PLANNING AND ZONING BOARD MEETING

Date: February 6, 2022
 To: Planning and Zoning Board
 From: Ellen Hardgrove, City Planning Consultant
 Allen Lane, CPH Engineering, City Engineering Consultant
 Jim Winter, CPH Engineering, City Landscape Architect Consultant
 XC: Sandy Riffle, Interim City Clerk
 Brett Sollazzo, Administrative Assistant
 Drew Smith, City Attorney
 Re: Mecatos Bakery and Café Site Plan/Waiver/Variance Application

Approval of the Mecatos Site Plan Package submitted electronically to City Hall January 25, 2022, subject to the following changes made and represented on the revised plans as clouded information, a revision note added to the plans, and as well as a written response to all needed changes listed below to be submitted to City Hall by February 28, 2022 at noon.

SITE AND GEOMETRY PLAN
Scale: SEE SHEET
Date: 2021-10-25
Project No: 7891000

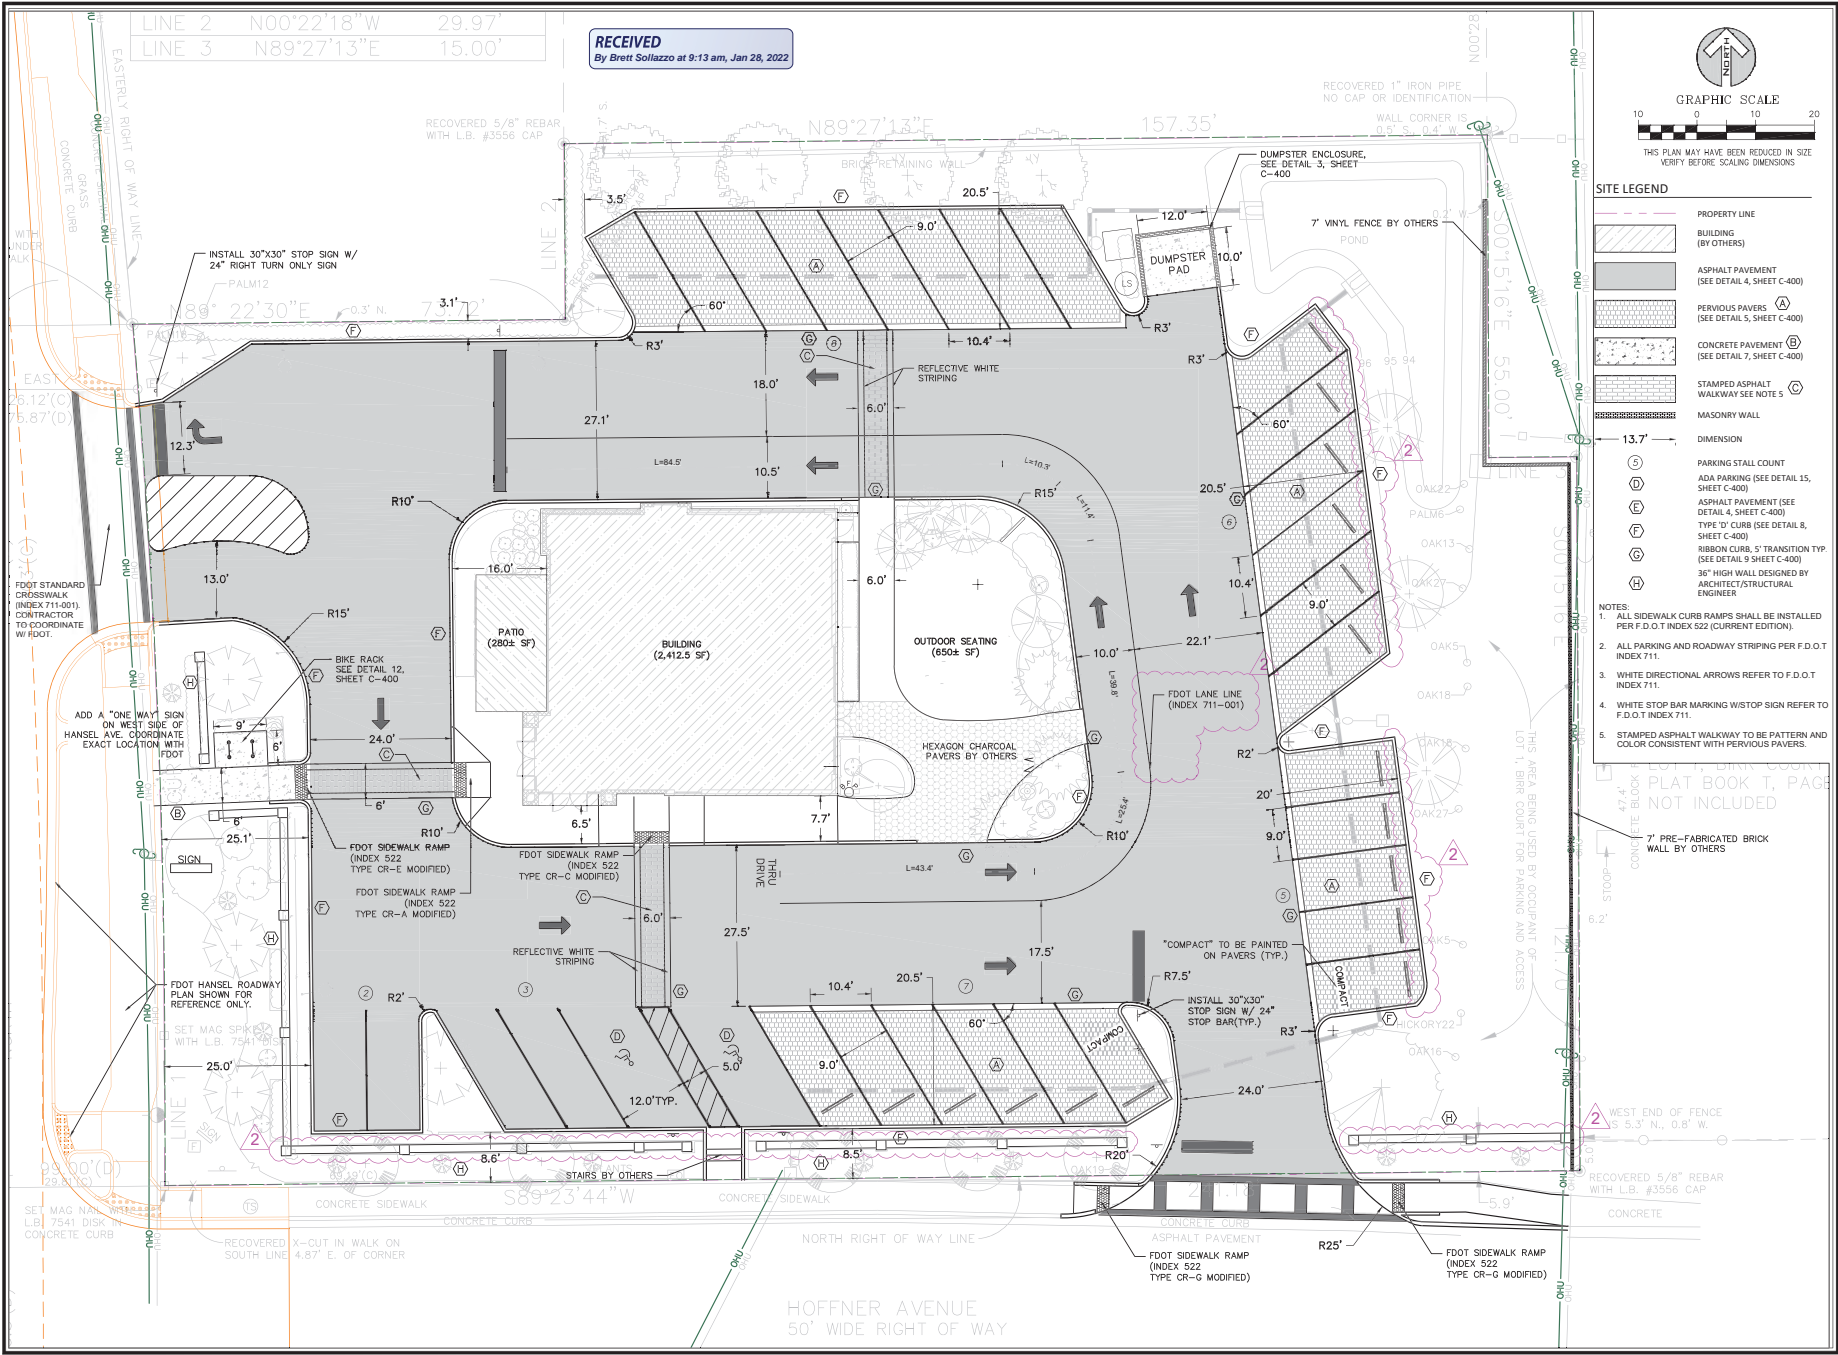
17. Sheet C-001 Standard Sewer and Water Notes – correct numbering under this section, some note numbers are repeated.
 18. Sheet C-100, change the lane line separating the drive-through from the circulating traffic to one single solid white line and add note referencing the lane line width and color.

19. Sheet C-100, add the radius for the curbing on each side of the entrance/exit to Hansel Avenue verifying that the Fire Truck Turning Radius Plan, which is to be a 30-foot radius, is provided.

20. Sheet C-100, add the call out for the Stop Sign and Right Turn Only Sign at the drive lane connection to Hoffner Avenue.
 21. Sheet C-300, eliminate the bend in the proposed gravity sanitary sewer to provide for a straight connection between the grease trap and the lift station.

UTILITY PLAN

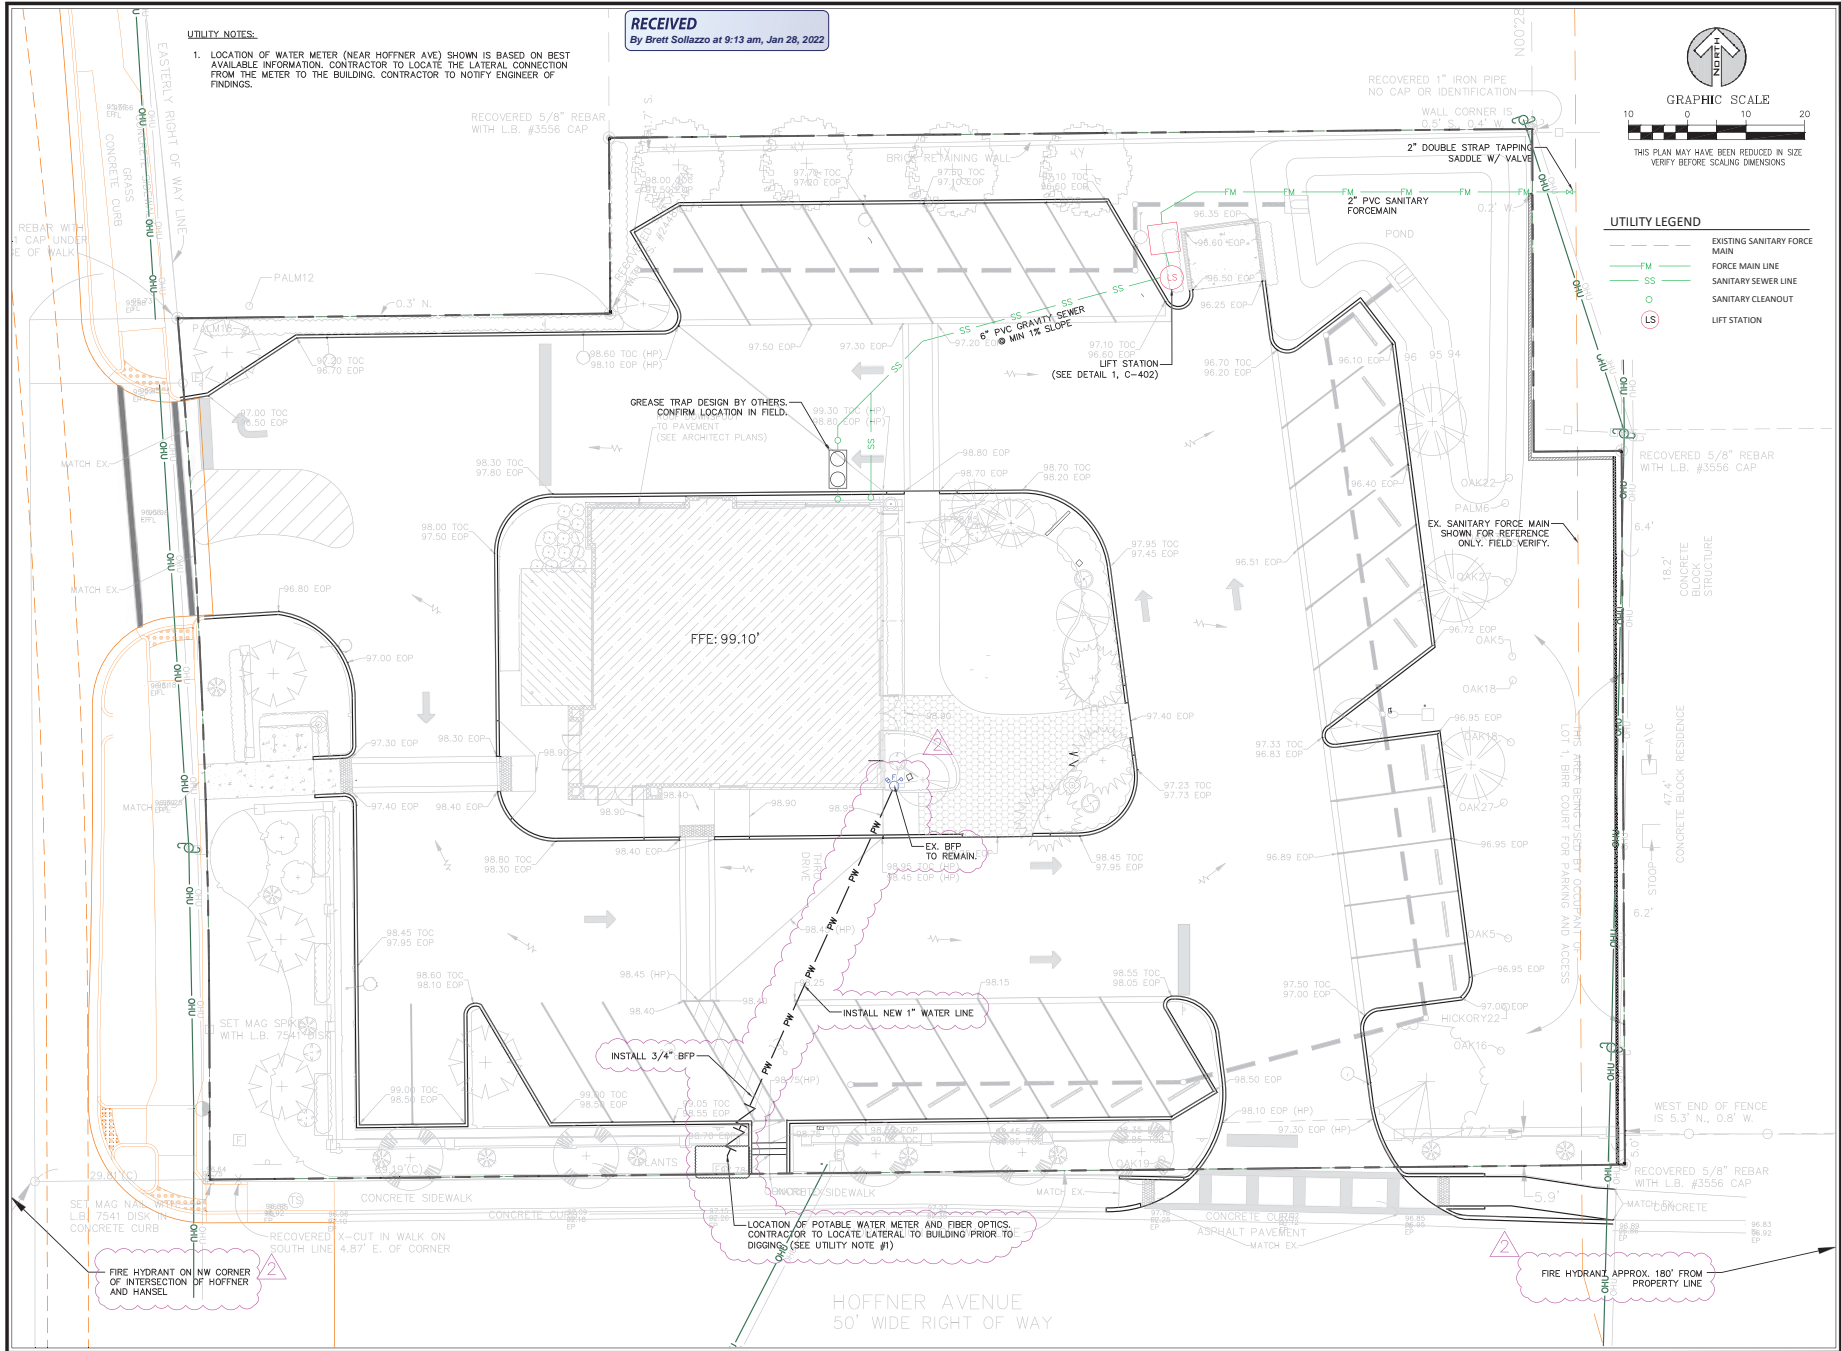
22. Sheet C-300, add notes to this plan sheet as well as the detail sheet referencing the installation and inspection of the new 1-inch water service and backflow prevention device shall be provided by Orlando Utilities Commission (OUC) prior to placing the water line into service.

23. Sheet C-300, add a note on this sheet for the contractor to coordinate with Orange County for the connection to the off-site force main when the tap to the existing force main is made.

LANDSCAPE SITE PLAN FOR
Mecatos Cafe

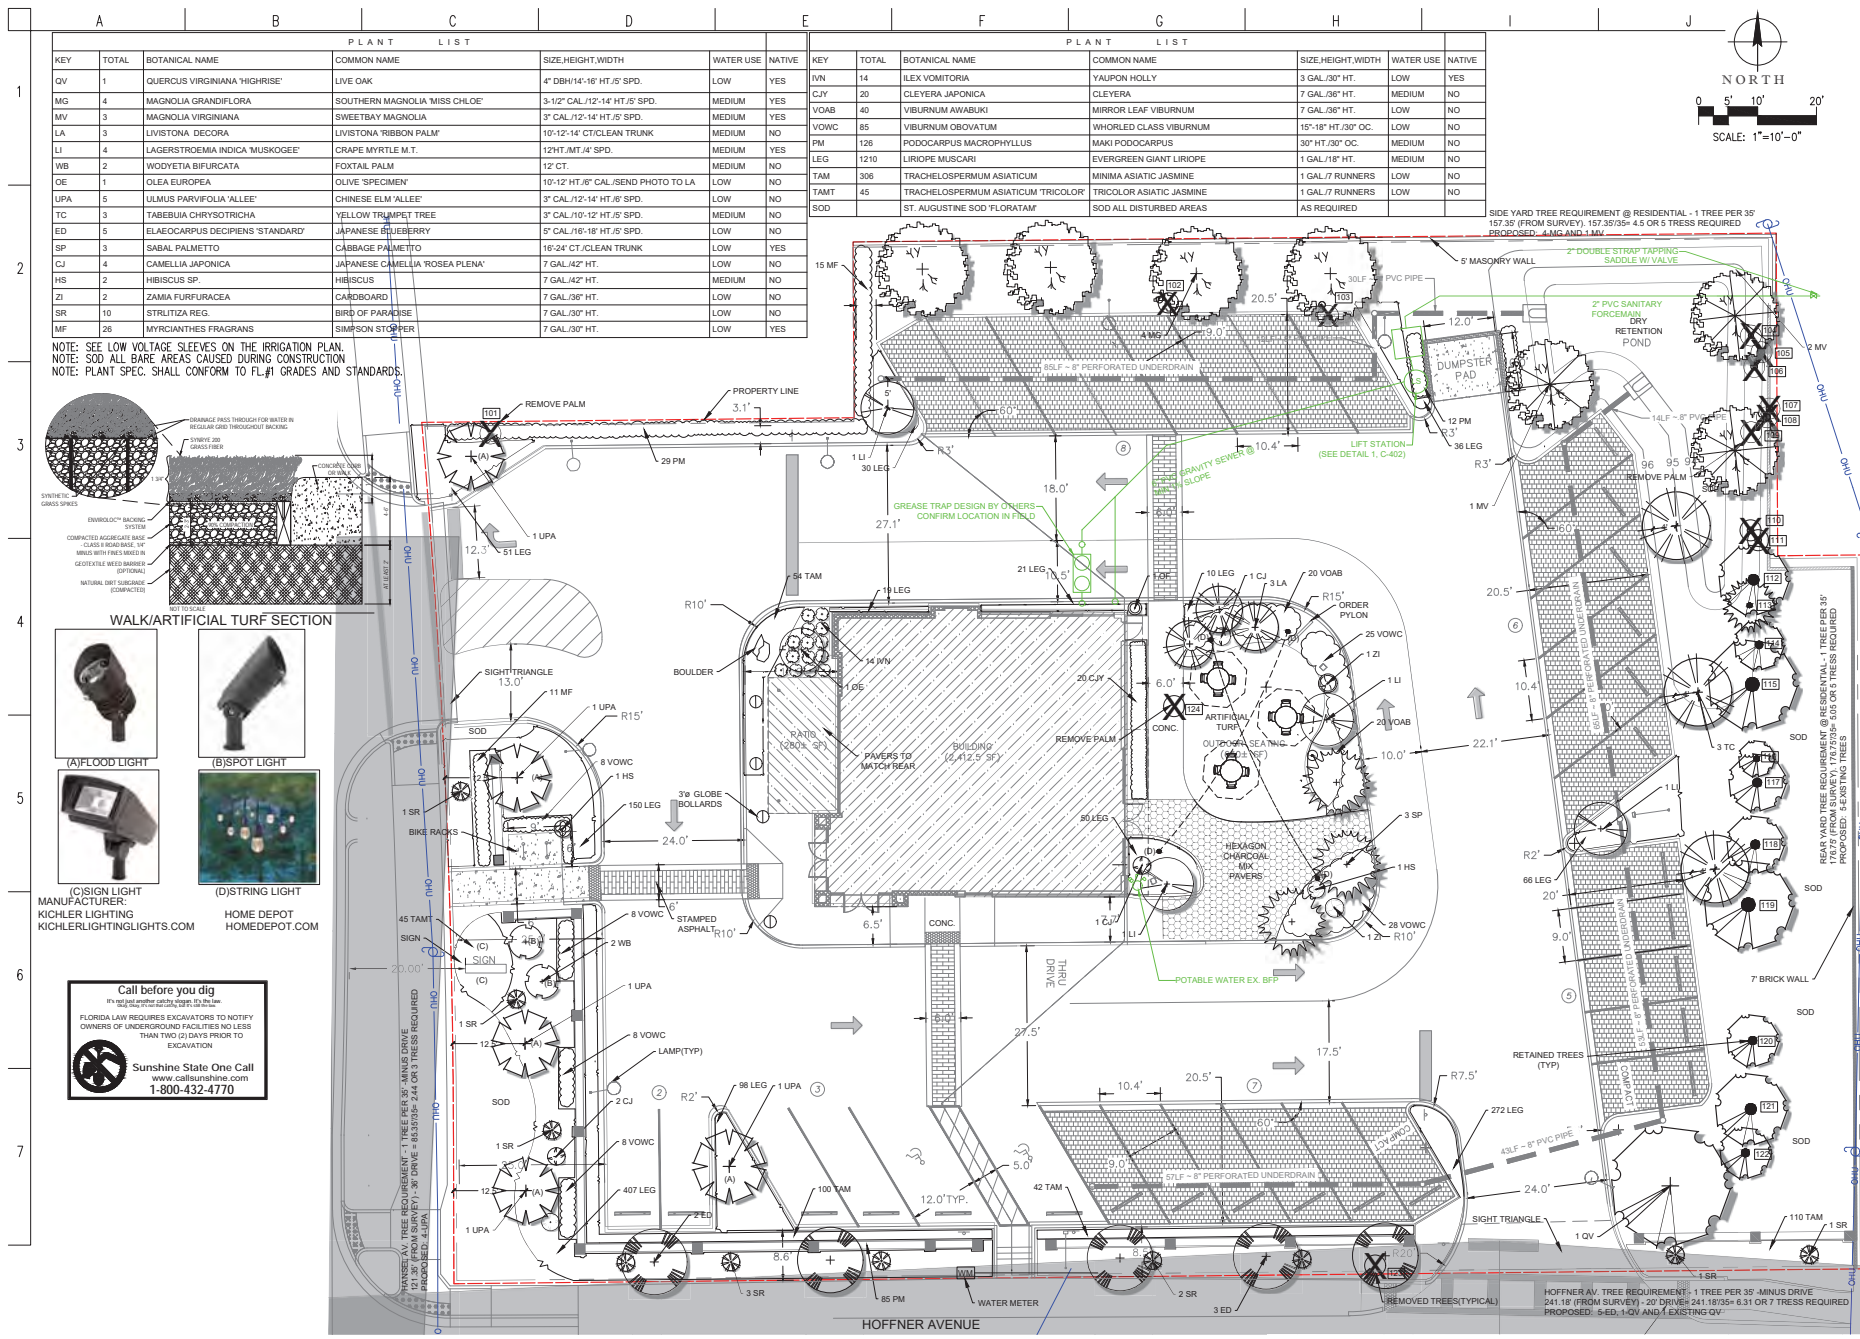
4. Landscape Plan, Exchange the Crepe Myrtle at the west end of north parking row for an evergreen shade tree.
5. Landscape Plan, Revise the Hoffner Avenue landscaping, on the street side of the wall, to provide a balanced tiered planting of groundcover, shrubs and accent plants that provide interest to the landscape similar to what is proposed on the Hansel Avenue frontage. The planting of primarily lirope in front of the wall does not meet this intent.

6. Landscape Plan, Revise the Hoffner Avenue trees to be understory trees spaced at 20’ on center.
7. Landscape Plan, Specify on the plan for trees and shrubs and ground cover in the visibility triangles FDOT’s required clear trunk measurements and the maximum shrub and/or ground cover heights.
